**FINAL**  
**RECORD OF DECISION (ROD)**  
**SITES REQUIRING INSTITUTIONAL CONTROLS**  
**IN THE PLANNED INDUSTRIAL/OFFICE**  
**DEVELOPMENT OR WAREHOUSING AREAS**  
**SENECA ARMY DEPOT ACTIVITY**

**FINAL  
RECORD OF DECISION  
FOR  
SITES REQUIRING INSTITUTIONAL CONTROLS IN THE PLANNED  
INDUSTRIAL/OFFICE DEVELOPMENT OR WAREHOUSING AREAS  
SENECA ARMY DEPOT ACTIVITY  
ROMULUS, NEW YORK**

**EPA Site ID No.: NY0213820830  
NY Site ID No.: 8-50-006  
DACA87-95-D-0031, Delivery Order 21  
736026**

**September 2004**

FIGURE 1-2  
 EXTENT OF PID AREA  
 LAND USE RESTRICTION

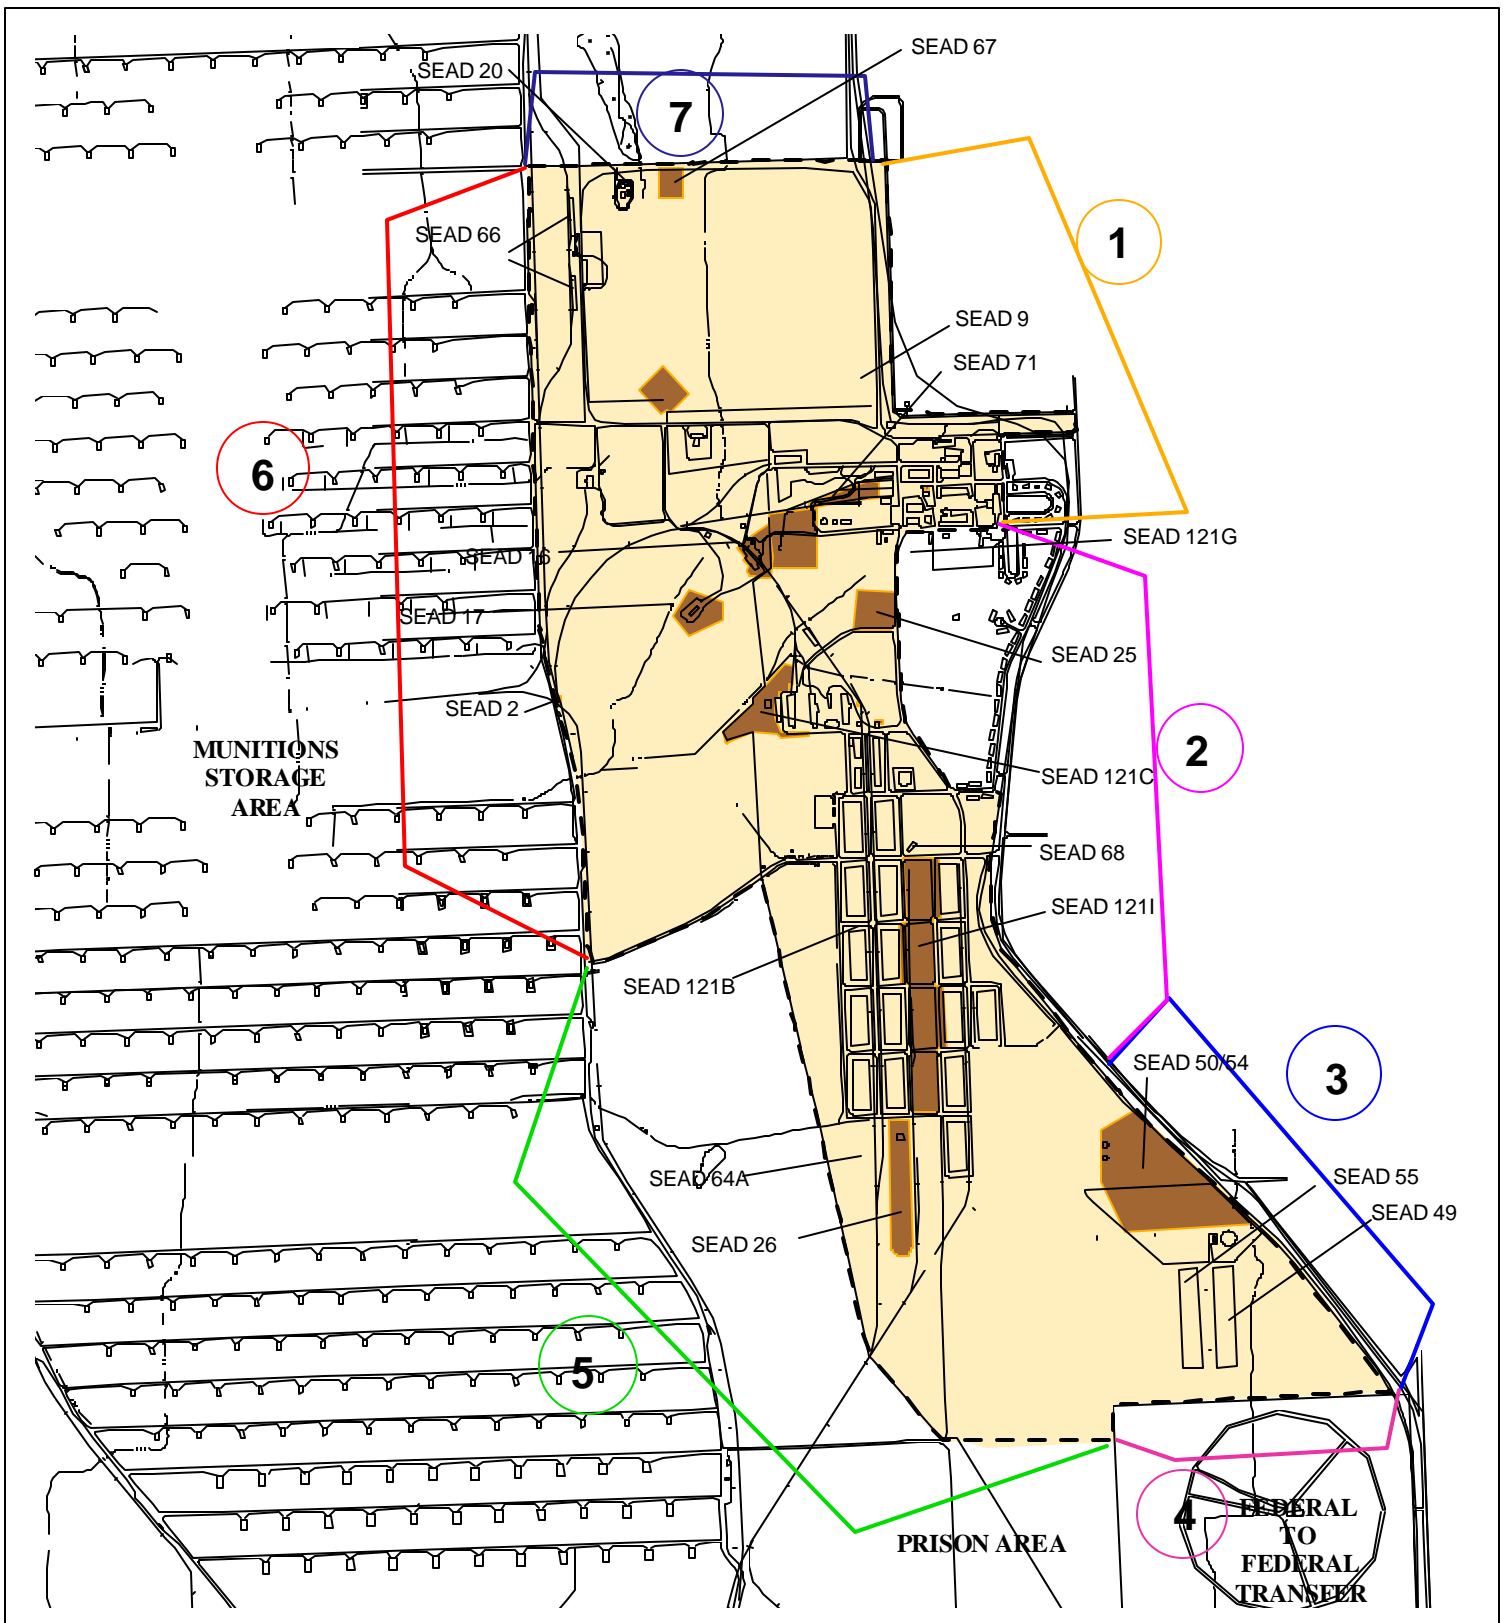
On Figure 1-2, I think the reference to "no residential activity, should include the other activities "childcare, playgrounds, elementary and secondary schools". Also, I do not see the restriction or 64A about no unauthorized excavation.

Agreed. Changes have been made to the legend of Figure 1-2 to reflect the land use restriction language that is contained within the main body of the ROD text. Additionally, the prohibition to digging at SEAD-64A has also been added.
